Product Change Notification

PCN number: PCN_COIN_PUCK_20201006_EN

Date: 2020.10.06

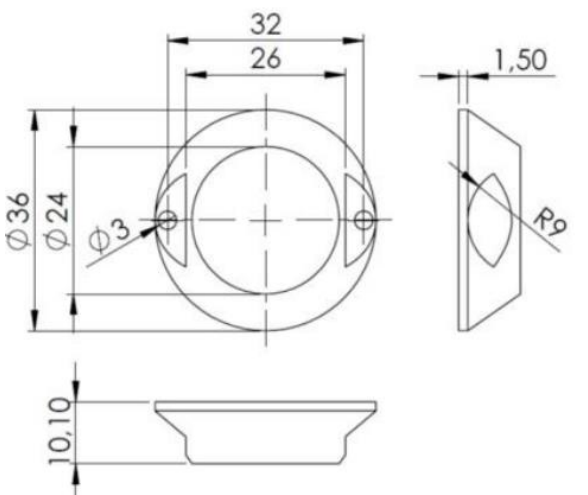
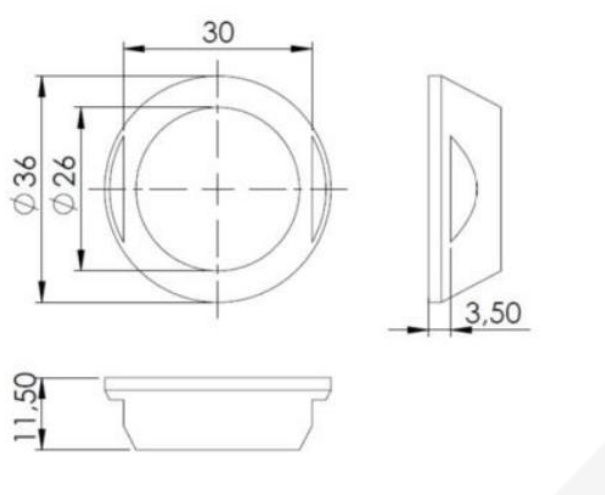
Change description		
Change type	External/visual	
Detailed description	Various changes were made in ELA beacons and sensors COIN/PUCK cases designs to optimize manufacturing and to increase rigidity. Case will be improved by reinforcing its walls. Screw holes will be removed.	
	<p>Old COIN/Magnet version:</p> 	<p>New COIN/Magnet version:</p> 
	<p>Old PUCK version:</p> 	<p>New PUCK version:</p>

Change reasons	Optimization of the production capacity. Reinforcement of walls for increased mechanical crush, shock and vibration resistance. Greater resistance of the material to UV waves
Product release date	Devices with new case design were released in manufacturing from October.
